VOLCANO HEIGHTS

Sector Development Plan

LUPZ Redline
March August 2012

Redline Note for Reviewers:

Exhibit 4.10 – Street Type 4.1: Park Edge Single-Loaded Cross Section

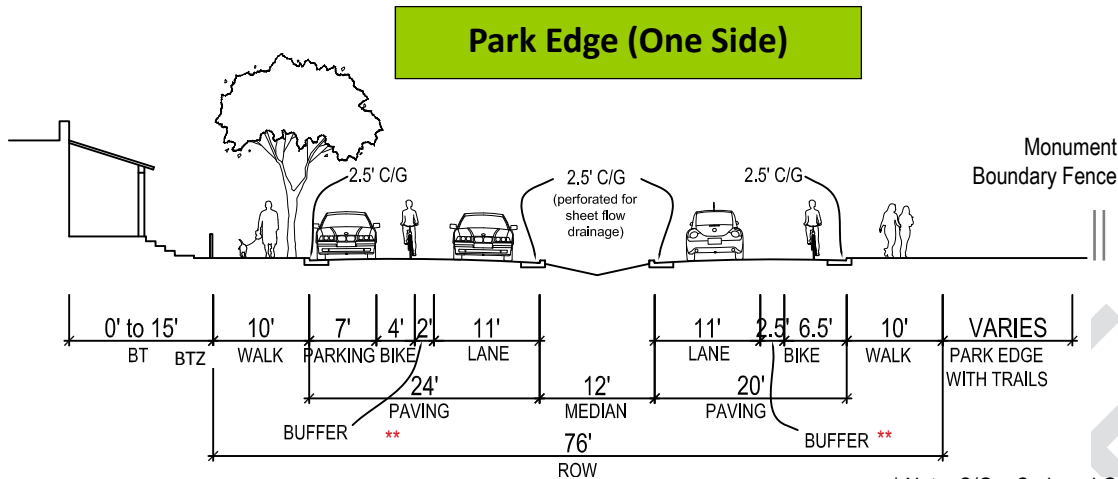
[37]
[38]
[39]

Exhibit 4.11 – Street Type 4.2: Park Edge Double-Loaded Cross Section

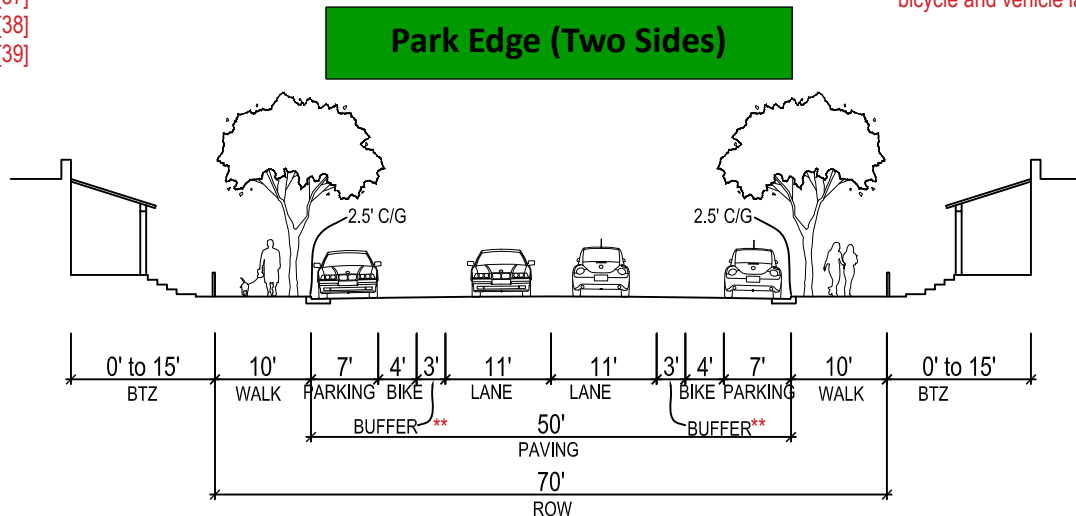
[37]
[39]

Exhibit 4.12 – Street Type 4.1: Typical Intersection (Plan View)

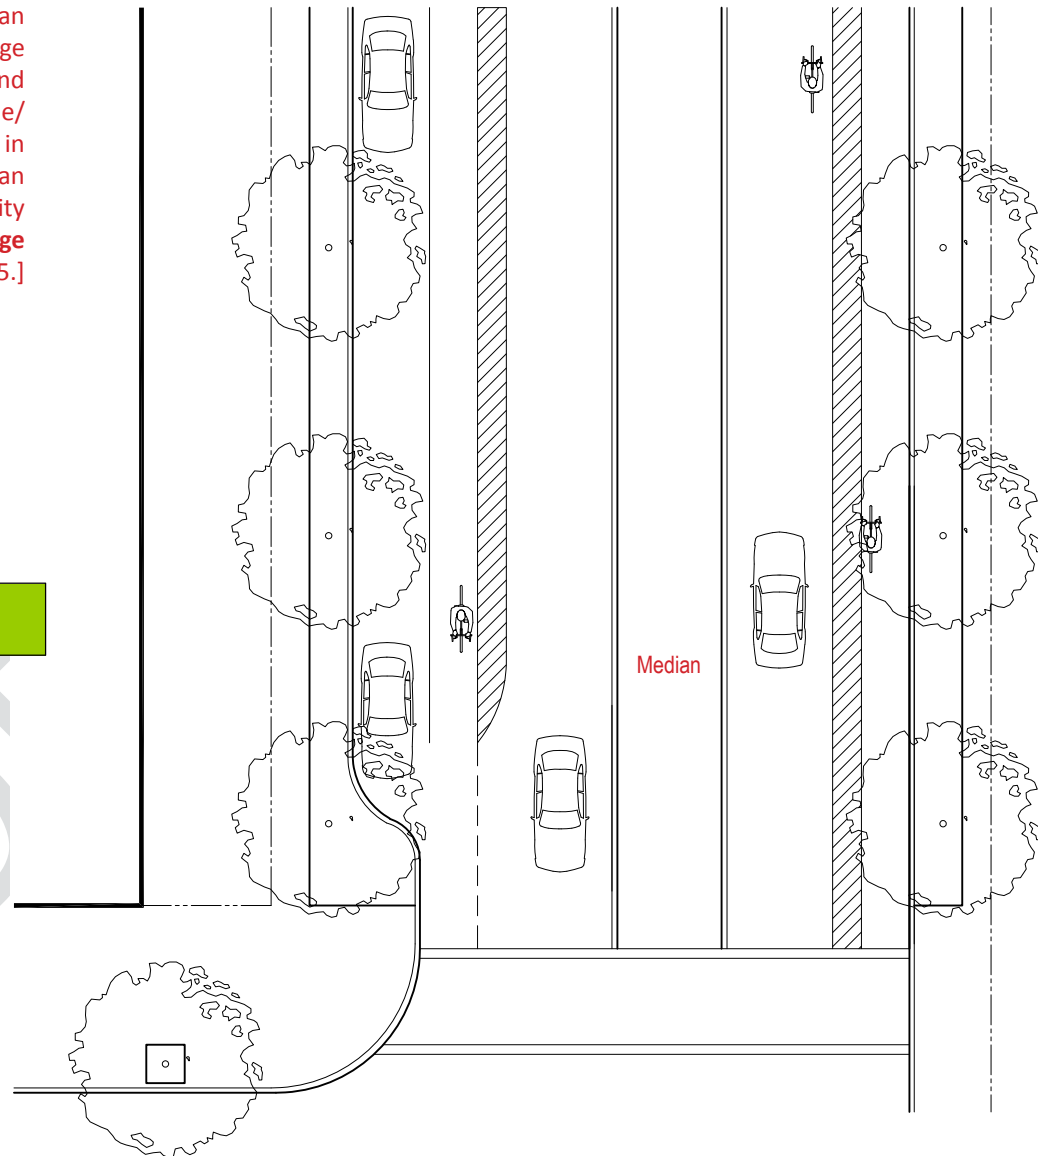
[41]
